Service Bulletin

Bulletin No.: 17-NA-226

Subject: Clicking and/or Popping Noise While Turning Steering Wheel Lock to Lock

Brand:	Model:	Model Year:		VIN:		Engine:	Transmission:
		from	to	from	to		
Cadillac	CT6	2016	2018

4830353

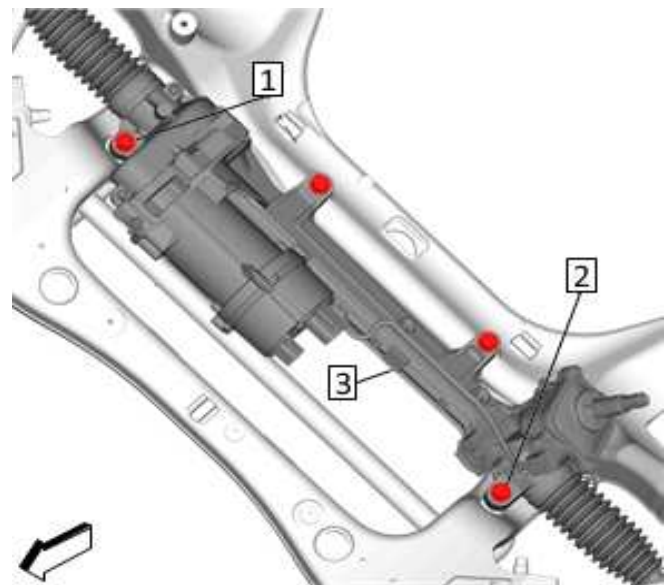
Involved Region or Country	North America and N.A. Export Regions
Condition	Some customers may comment on hearing a clicking and/or popping noise when they are turning the steering wheel from lock to lock, and the noise can be heard when the vehicle is stationary.
Cause	This condition may be caused by insufficient torque load on the front two steering gear to cradle bolts.
Correction	If the noise can be validated to be coming from steering gear movement, the front steering gear bolts must be replaced with new bolts and torqued to specifications.

1. Remove the front tires. Refer to *Tire and Wheel Removal and Installation* in SI.
2. Starting with the driver side, remove the steering gear front cradle bolt (2) and discard.
3. Using a flex head torque wrench, torque the new bolt to 58 N•m (43 lb ft) plus 35 to 40 degrees.
4. Repeat the steps for the passenger side bolt (1).

5. Install the front tires.
6. With the vehicle on the ground, turn the steering wheel lock to lock.
 - If the noise was eliminated, do not proceed.
 - If the noise has not been eliminated, Technical Assistance (TAC) must be notified for further diagnostics.
